# ADDENDUM NO. 2

# Citywide Adaptive Signal Control System – ITS Improvements – Phase 1 & 2 and Phase 3 RFB # 19-011

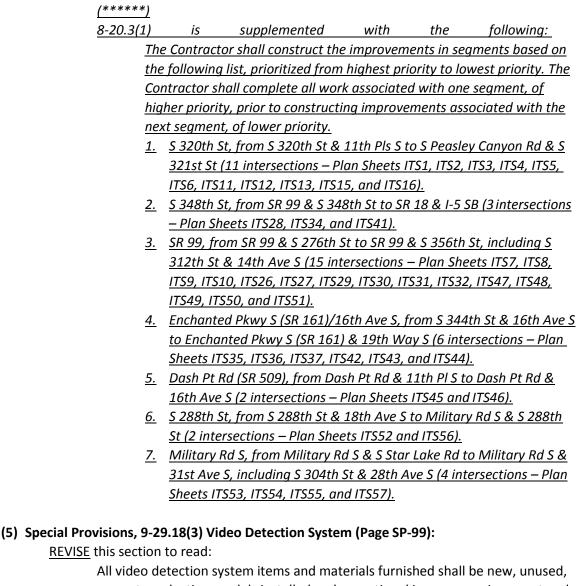
### (3) Special Provisions, 8-20.3(1) General (Page SP-62):

<u>REVISE</u> the second subsection to read:

The Contractor shall remove and relocate existing video detection cameras for re-use on other parts of the project as shown in the Plans.

The following table regarding detection quantities is approximate and is provided for the Contractor's reference only:

\* Contractor may evaluate the potential to reduce the number of new video detection racks needed, per the Special Provisions.
